Access Compliance Report

Public Rights-of-Way

Intersection ID: 27404	Main Street: BALLANTYNE COMMONS PY	Cross Street: MEADOW RUN LN	Location:	NW
ADA ID: 7D7F1C0FC359	Ramp Type: Perp	Initial Pass/Fail: Fail	Overall Compliance: No	Severity Score: 10
Codes/Mitigation Info/Possible Solution		Field Measurements/Component Compliance

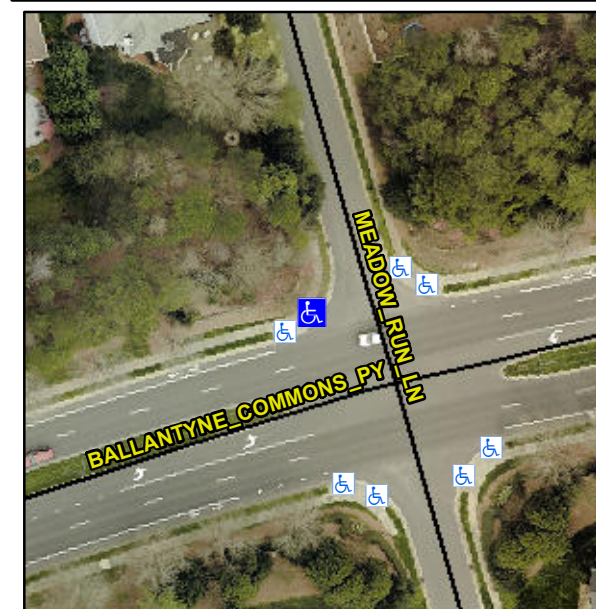
Not Found, R304.5.1, R304.5.3

Compliance	Description	Data	Compliance	Description	Data
N/A	Ramp Length (in)	105.0	Yes	Ramp Slope (%)	7.9
No	Ramp Width (in)	37.0	No	Ramp XSlope (%)	2.9
N/A	Flare Type LT	N/A	N/A	Flare Type RT	N/A
N/A	Flare Slope LT (%)	N/A	N/A	Flare Slope RT (%)	N/A
N/A	Flare Traversable LT?	N/A	N/A	Flare Traversable RT?	N/A
N/A	Landing Length (in)	N/A	N/A	DWS Provided?	N/A
N/A	Landing Width (in)	N/A	N/A	DWS Contrast?	N/A
N/A	Landing Slope (%)	N/A	N/A	DWS Length (in)	N/A
N/A	Landing X Slope (%)	N/A	N/A	DWS Full Width?	N/A
N/A	Landing Curb? (Y/N)	N/A	N/A	DWS Offset (in)	N/A
N/A	Shared Landing?	N/A			
N/A	Gutter Ponding?	N/A	N/A	Gutter Slope (%)	N/A
N/A	Gutter Lip Ht (in)	N/A	N/A	Gutter X Slope (%)	N/A
N/A	Painted X Walk1?	No	N/A	Painted X Walk2?	N/A
	X Walk 1 Direction	To NE		X Walk 2 Direction	N/A
N/A	X Walk 1 Width (in)	N/A	N/A	X Walk 2 Width (in)	N/A
	X Walk 1 Slope (%)	2.0		X Walk 2 Slope (%)	N/A
	X Walk 1 X Slope (%)	2.2		X Walk 2 X Slope (%)	N/A

Remove & Replace Entire Ramp.
